**TOWN OF BRUNSWICK**

**DRAFT Findings of Fact  
Major Development Review  
Final Subdivision Plan  
April 14, 2015**

**Project Name:** Chamberlain Woods Subdivision  
**Case Number:** 15-002  
**Zoning:** Town Residential 5 (Columbia Ave – Spring St (TR5))  
**Tax Map:** Map U27 Lot 6  
**Applicant:** Coastal Building and Investments, Inc.  
141 Pleasant Street  
Brunswick, Maine 04011

**Subject:** Proposed Major Subdivision Plan Application-Engineering Consultant Review  
Of Chamberlain Woods Subdivision-Boody Street Extension

Figure 1

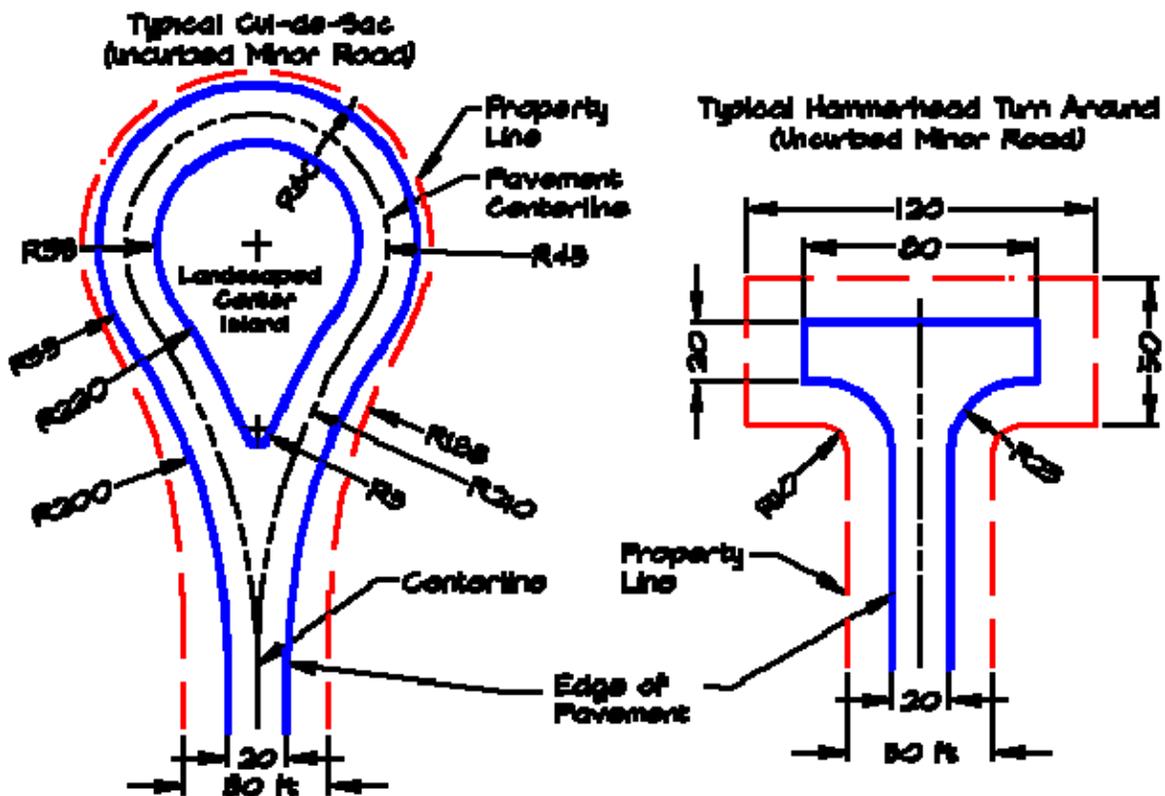
1. The pavement radii in the cul de sac is not acceptable and does not meet our design standards as contained in the town's street acceptance ordinance. See Figure 1 below as shown in the ordinance. A centerline radius of 45 feet is required and sheet C3 indicates it will be 34 feet, that is way too small and tight. I am sure the project can comply as the property line radius is as required, just need to revise the pavement radii in the cul-de-sac and resubmit for approval.

**A** CROSS-COUNTRY DRAINAGE PROFILE - 20+00 TO 25+14  
N.T.S.

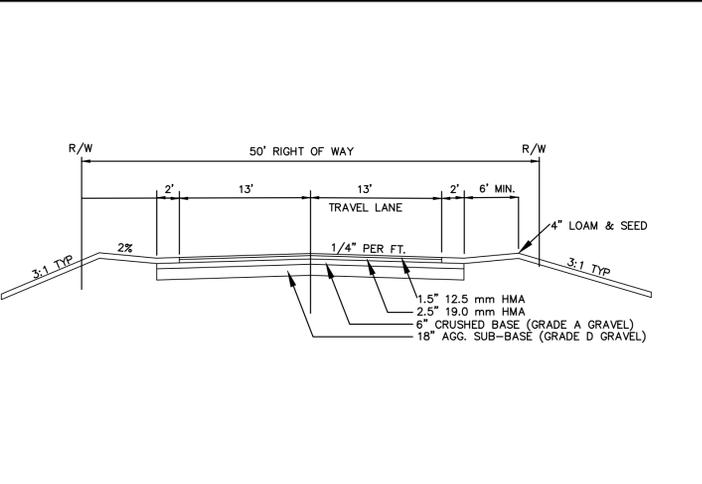
5. During construction there will need to be a dewatering plan in place in the event that during construction we either have high water situations in the ground or experience a large rain event to cause a rapid rise in groundwater. The plan shall address how the contractor is to collect, drop groundwater levels, and where to discharge clean water into the city system. *We received the Dewatering Plan and revised detail as shown on sheet C8 - Erosion Control Detail and Notes. We would recommend the following be added to the plan or detail:*

- A. *Improve the detail or add notes indicating that the sump for the collection of groundwater should be lined with crushed stone to*

- B. Improve the detail to show a stone dam separate the incoming drainage from the pump side such that the stone creates a fore bay effect and allowing less turbid water to be pumped away.*
- C. Add a note or requirement that prior to any pumping that the Town Engineer review and inspect the program prior to activation to assure Town infrastructure is well protected from impacts.*

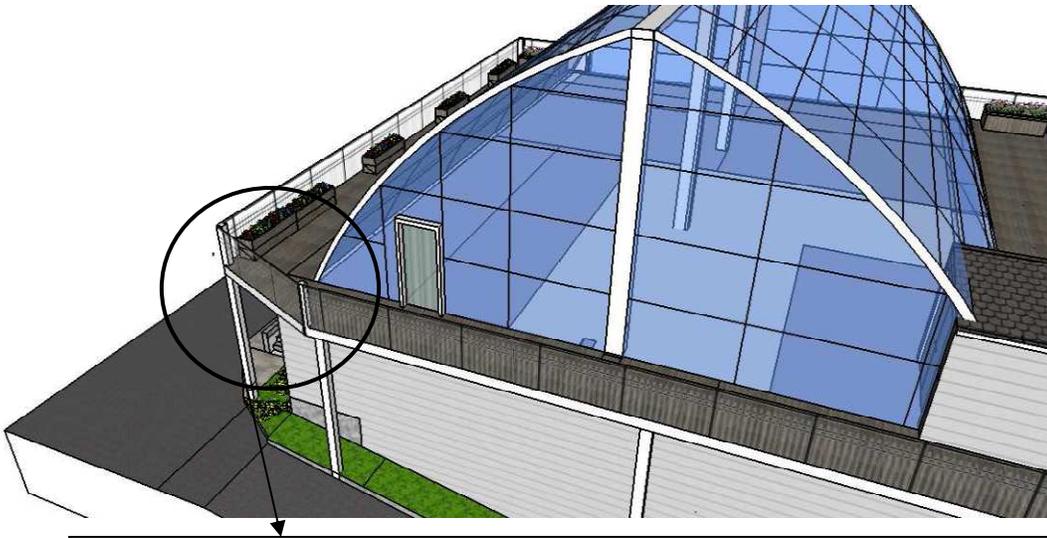
- Office space must be ADA compliant (ramp and bathrooms). Currently is not designed as such. Suggested installation of an elevator or internal lift. Ramping isn't possible due to building design.
- Will need at least a 3x3 landing at each of the three front entrances facing Abbey Road.
- Question status of 2014 approved plan amendment. JS stated that the existing diagonal parking spaces will be realigned as part of this project. May request approval to construct an outside patio along west side of structure at a later date.
- Noted tight parking configuration on existing lot. JS – proposed building being slightly moved to north.
- Show existing curb and existing lighting on plan.

The east side entrances have been recessed slightly to allow for a 3'x3' landing.

Tire stops will be installed to prevent parking cars from bumping the building.

The deck has been slightly altered to prevent an overhang in the road, therefore eliminating the potential of obstructing access for tall vehicles.
